**METROPOLITAN GOVERNMENT  
OF NASHVILLE AND DAVIDSON COUNTY**

**Minutes  
Of the  
Metropolitan Planning Commission**

*November 14, 2006*

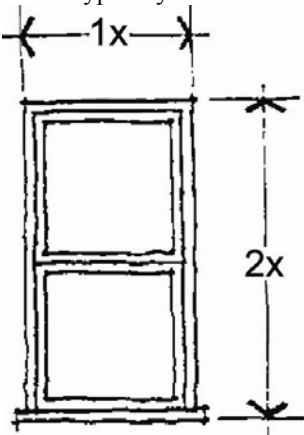
The submitted drawings for the Westin Hotel show:

Building	Height	Distance from	Percentage (ht./dist.)
<u>Broadway</u>			
Westin Hotel	45'	On Broadway	
Westin Hotel	144'	64'	225%
Westin Hotel	200'	108'	185%

## Upper Story Window Proportions

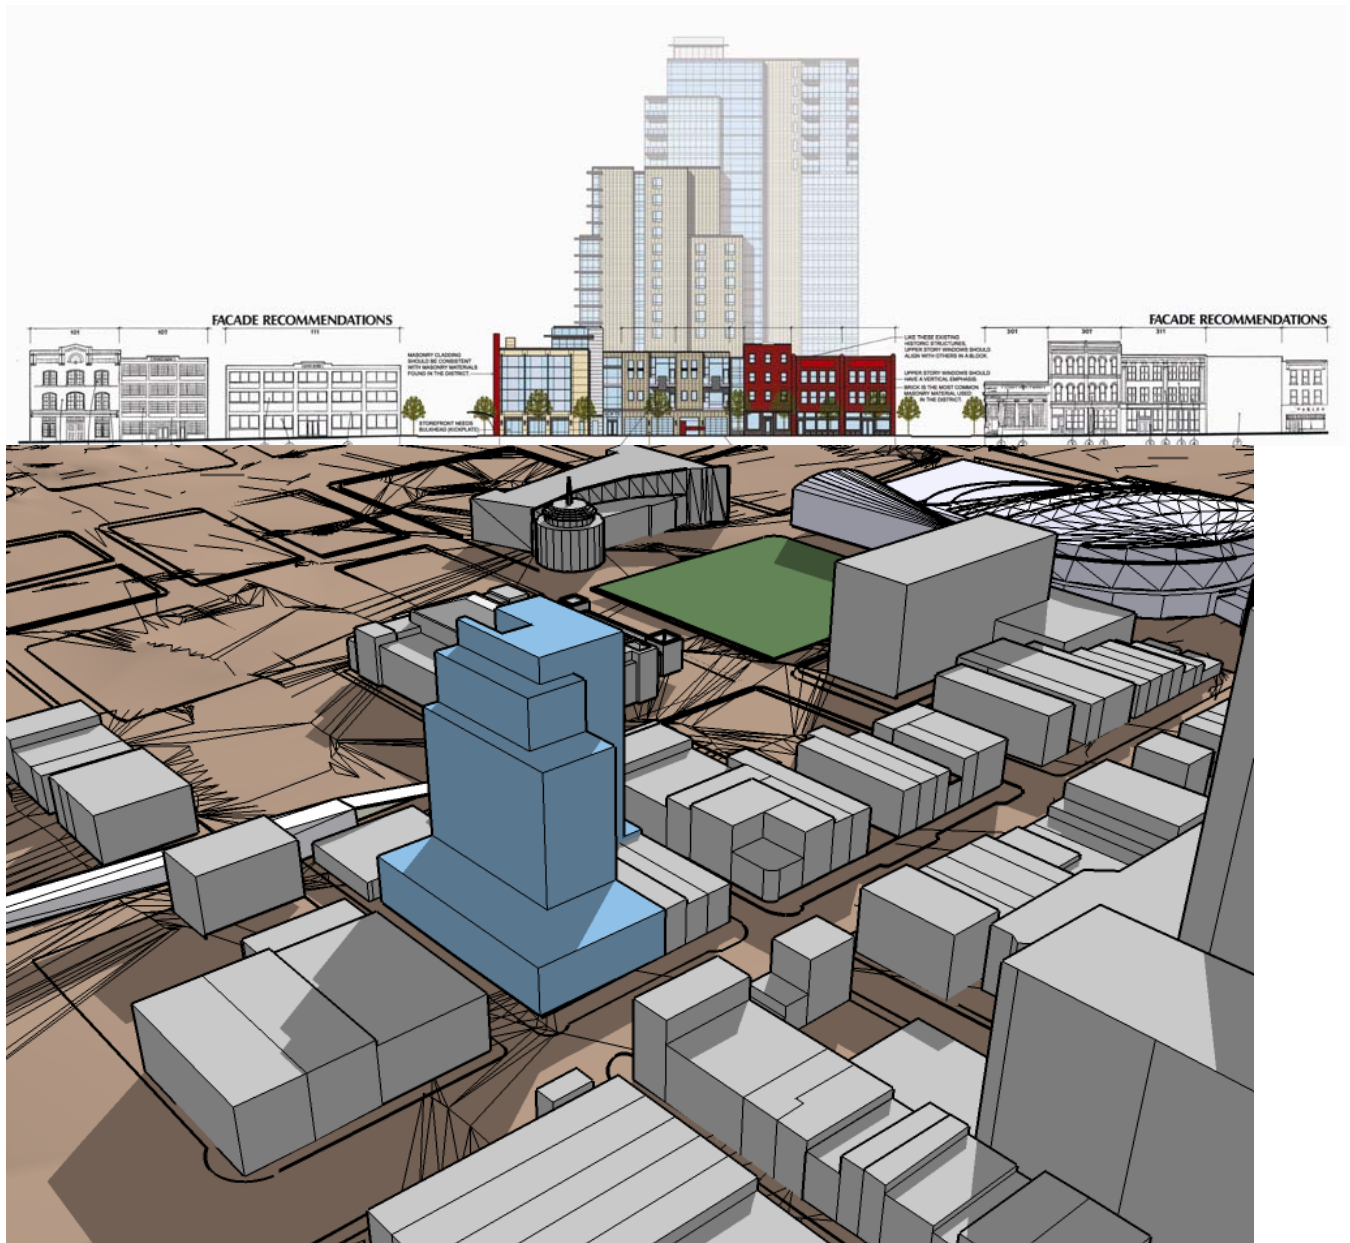
**Proportion and Rhythm** -The architecture elements for the proposed Westin are not consistent with the existing architecture found along Lower Broadway. Compatible design for new structures and additions is important in historic districts such as Lower Broadway. New buildings within historic districts should reflect the architecture of their time. Therefore, new construction should not attempt to imitate or copy old architecture, however, new buildings should relate to the existing buildings on Lower Broadway in terms of height, mass, ratio of solids to voids and materials. The proposed Westin project is not consistent with the existing buildings found along Lower Broadway in terms of height, mass, ratio of solids to voids and materials. The materials used on the proposed Westin are not appropriate and are not similar to those used historically in the architecture of Lower Broadway and the materials do not convey a sense of scale similar to those seen in the Lower Broadway Historic District. The terra cotta wall material proposed for the Westin is not compatible with the Lower Broadway Historic District. Masonry is the traditional building material found in Lower Broadway with brick being the most common masonry used, although there are some examples of stone masonry along Broadway. Materials used on new construction should be similar in appearance, color, scale and texture to those used historically. The windows on the existing structures create a pattern and rhythm along Lower Broadway with the repetition of evenly-spaced, similarly-sized, upper story windows. These windows help give Lower Broadway a sense of human scale. Using window sizes and proportions that are familiar to the pedestrian helps them to relate to the overall size of a building. The alignment and similar scale of windows reflect a common historic pattern that should be continued along Lower Broadway. Currently, the proposed 45' buildings for the Westin that face directly onto Lower Broadway do not create the same rhythm and repetition with their windows as what historically exists along Lower Broadway. Upper story windows on Broadway buildings historically have a vertical emphasis with a typical upper-story window being twice as tall as it is wide. Upper-story windows in new construction should relate to the window proportions seen historically. For example, upper story windows do not typically exceed 6 feet in height and 3 feet in width.

Windows should align with others in a block similarly to the historic structures along Lower Broadway. Windows, lintels, and window trim elements should align with the historic buildings on the block, and the current Westin submittal does not. The current Westin submittal has translucent panels and glass curtain walls and these are not window configurations or materials historically seen along Lower Broadway.

Proposed Westin project looking down Lower Broadway

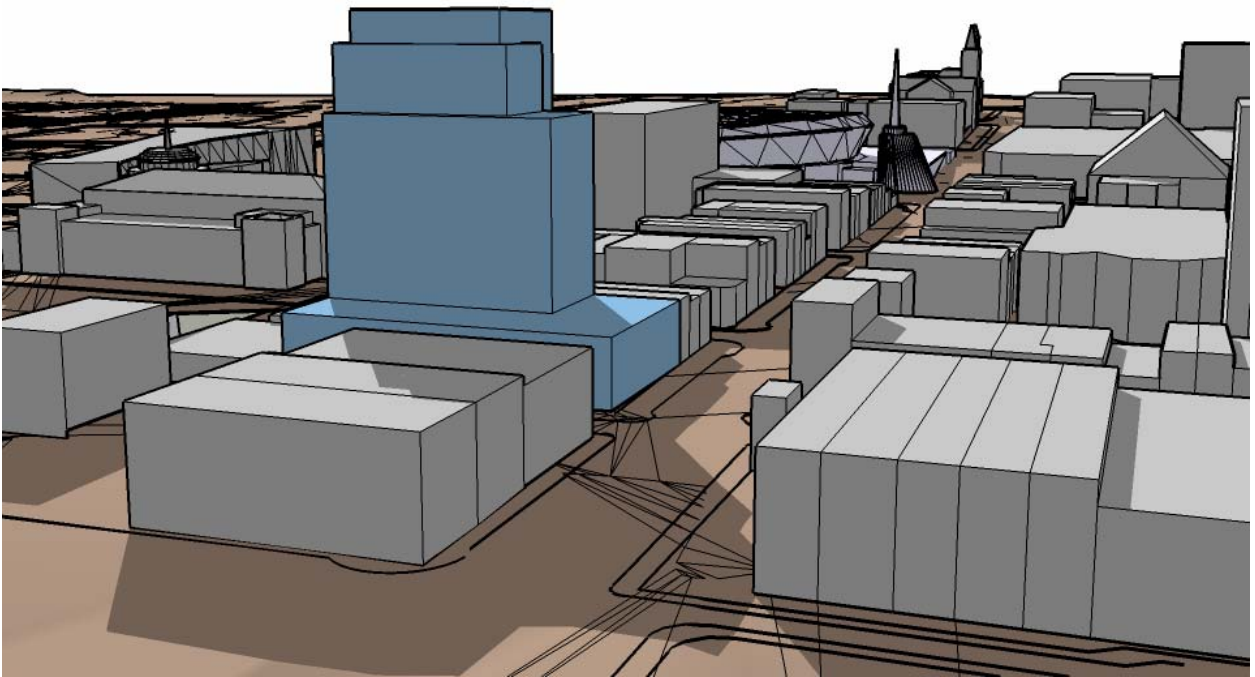
The repetition of recessed building entries occurring along the street in the Lower Broadway historic district provides a rhythm of shadows along the street, which helps establish a sense of scale and invites pedestrians to enter buildings. This trend should be continued in the Westin's new construction and building entrances from Broadway should appear similar to those used historically. The Lower Broadway Historic District should continue to develop as a pedestrian-oriented environment of ground floor storefronts. Buildings should relate to pedestrians by using materials and a human scale compatible with local historic patterns.
